UNITED STATES OF AMERICA
BEFORE THE
FEDERAL ENERGY REGULATORY COMMISSION

In the Matter of)	October 17, 2005
)	
State of California)	
Department of Water Resources)	Project No. 2100-52
)	
For a New Major License)	
Oroville Division, State Water Facilities)	
“Oroville Facilities”)

**MOTION TO INTERVENE
OF
FRIENDS OF THE RIVER
SIERRA CLUB
SOUTH YUBA RIVER CITIZENS LEAGUE**

Figure 3 Sectional view looking upstream at main spillway with a small portion of the overpour spillway to the left. ACE Reservoir Regulation Manual, 1970

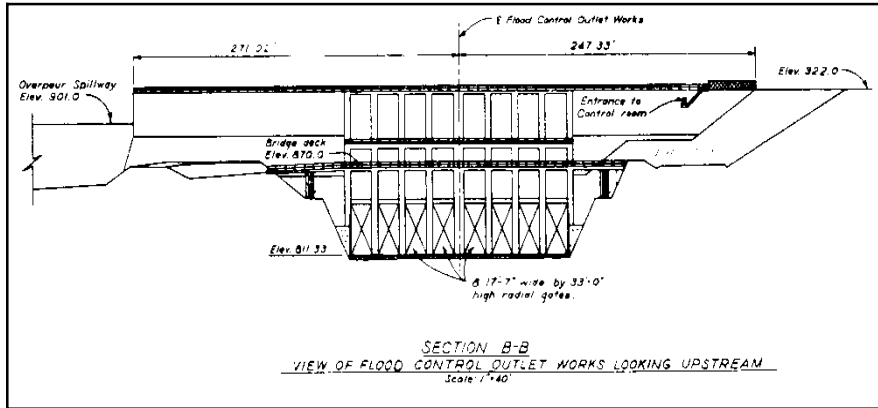
Oroville Dam includes two spillway facilities, the main spillway (controlled by gates) and an ungated “overpour” spillway, consisting of a 1,730 ft

long spillway lip (ogee crest) at elevation 901 feet, with no spillway below. Maximum surcharge operations envision 16 feet of water depth over the ungated spillway, plus additional freeboard space.³

Figure 8. Lookdown View. Main spillway gate above (with spillway extending to the right downslope). Ungated spillway below without any downslope spillway. See spillway sections used in figures 6 & 7. ACE, 1970

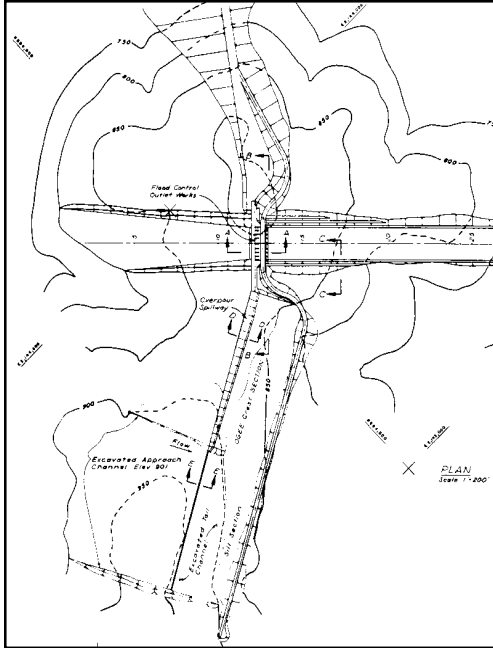
However, in the absence of Marysville Dam, the ACE Oroville Dam FCD calls for *operational* use of the ungated spillway. This is achieved by manipulating main spillway gates in order to make combined spillway releases equal to the regulated objective releases when reservoir levels are at 901 to 911—and water is freely flowing over the ungated spillway.

Obviously, a major issue in this relicensing is that the ungated spillway presently has the physical characteristics and consequences of use of an emergency spillway, but the required uses of an auxiliary spillway, imposing on the Commission the duty of requiring modification to the spillway.
